City of Santa Barbara California

PLANNING COMMISSION & STAFF HEARING OFFICER STAFF REPORT

REPORT DATE: May 4, 2006
AGENDA DATE: May 11, 2006
PROJECT ADDRESS: 822 E. Canon Perdido (MST2005-00506)
 824 E. Canon Perdido (MST2005-00504)
TO: Planning Commission and Staff Hearing Officer
FROM: Planning Division, (805) 564-5470
 Jan Hubbell, AICP, Senior Planner
 Irma Unzueta, Project Planner
 Chelsey Swanson, Assistant Planner

SITE PLAN

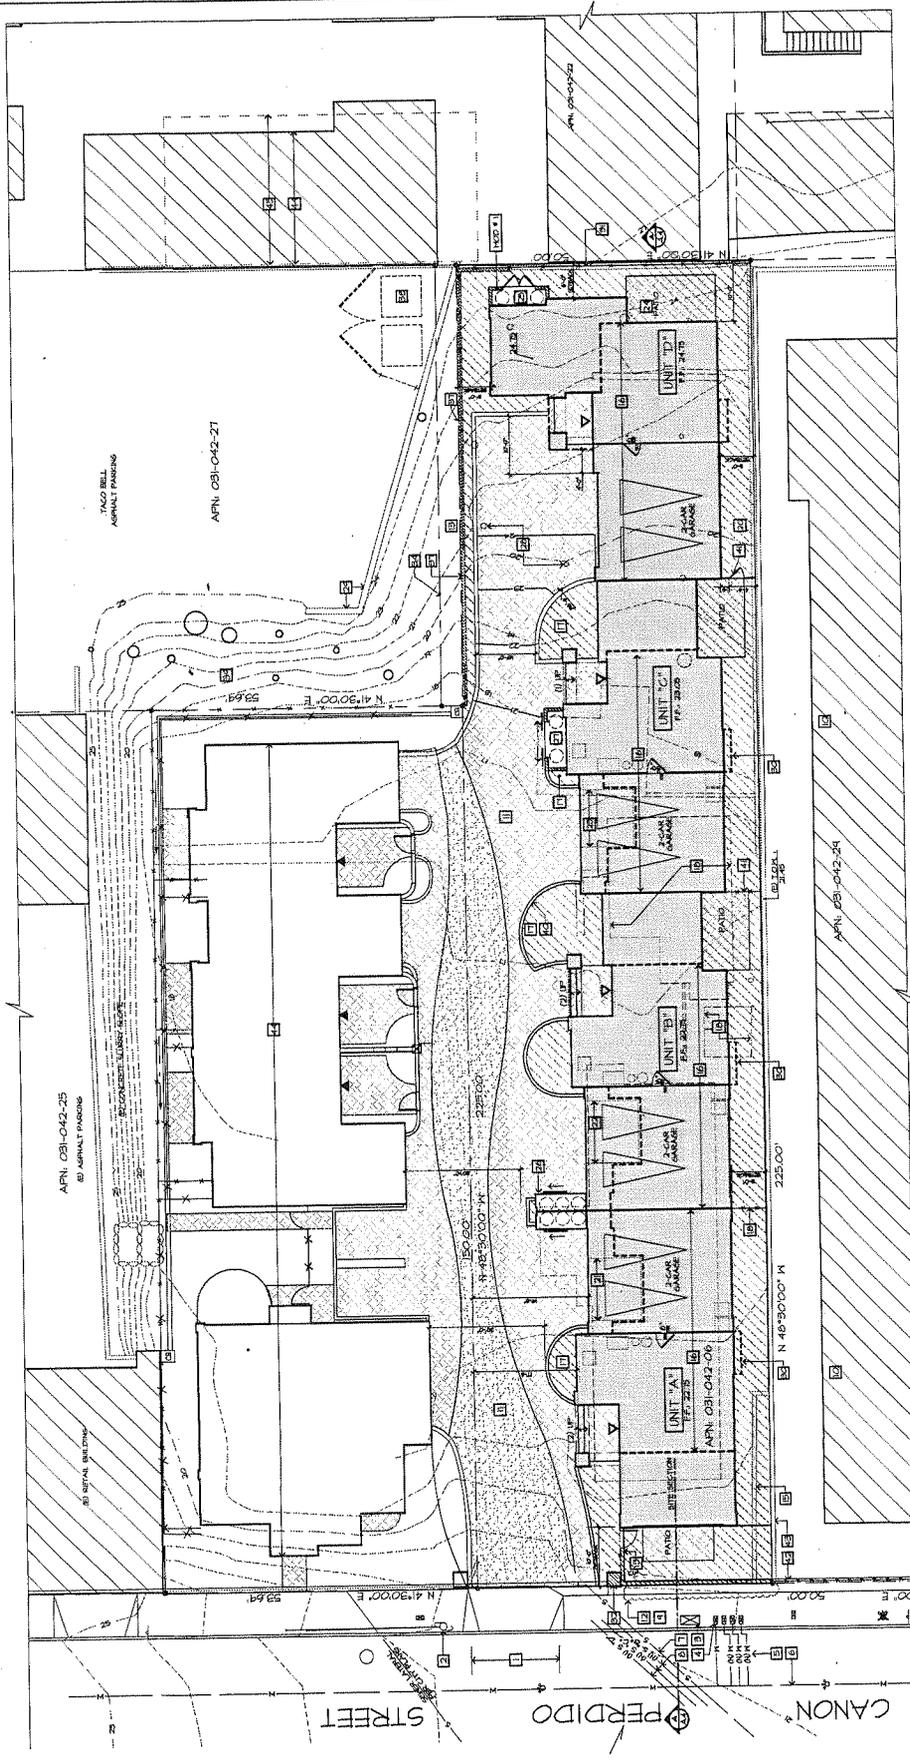
9. There is some repetition in the project description on Sheet A-1; please revise.
10. Change the APN on the sheet A-1 to read 031-042-006.
11. Please add the General Plan land use designation of "Residential, 12 units/acre", on the site data on Sheet A-1.
12. Include the 410 square foot existing garage under the existing square footages.
13. In addition to the proposed data listed under "Total Site Calculations" on Sheet A-1, please include the same information for the existing conditions on the property.
14. Please show elevations for buildings on adjacent parcels as seen from the west elevation (Canon Perdido Street). This may include a partial outline of adjacent buildings.

4. Sheet C2 shows construction of a 12" storm drain through private properties and under existing building to the southwest of said property. Is this an existing private storm system running under 820 East Canon Perdido Street? Please clarify.

5. The drainage plan is confusing as to how the drainage is being handled. Sheet A2 references new sump pump and civil drawings (Key Note 33) but I can't find either one.

6. The hedge shown in the public right of way on Sheet A2 shall be removed from the public right of way.
7. An Encroachment Permit is required for the kiosk and wall to be located within the 10' Canon Perdido Street setback (SBMC §28.83.027) and may be applied for at the Public Works Counter.

A.3

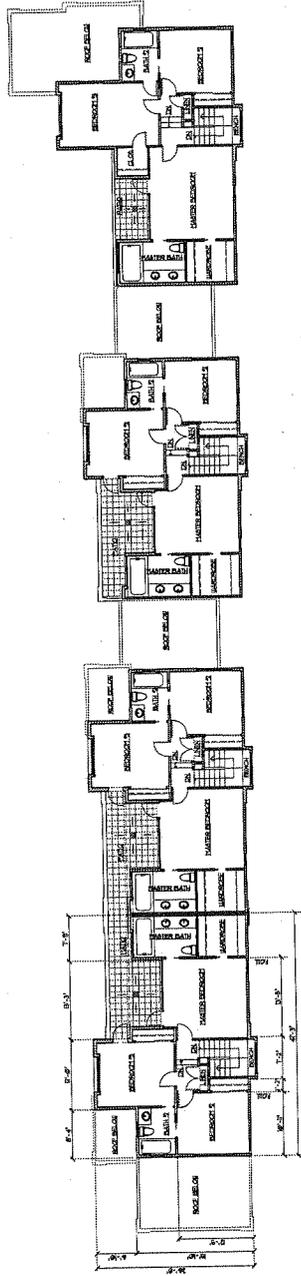
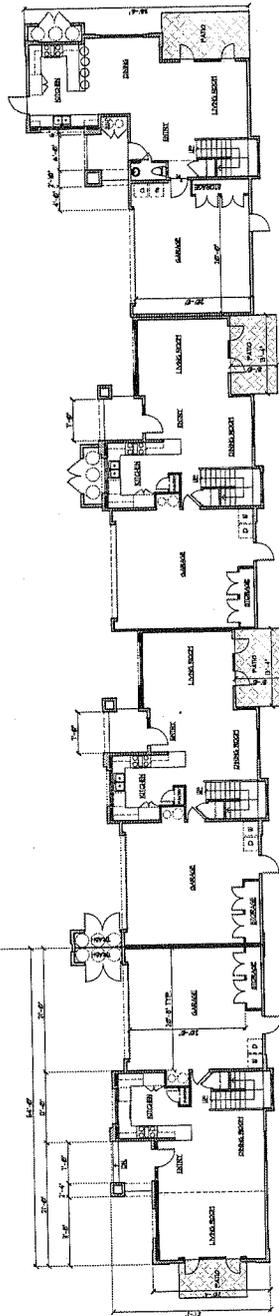
6. Please show a detailed section of the bay window projections for Units A, B, and C into the interior yard. Architectural features may encroach up to 2' into the setback; however, no additional floor area may be provided and no storage is allowed within this projection.
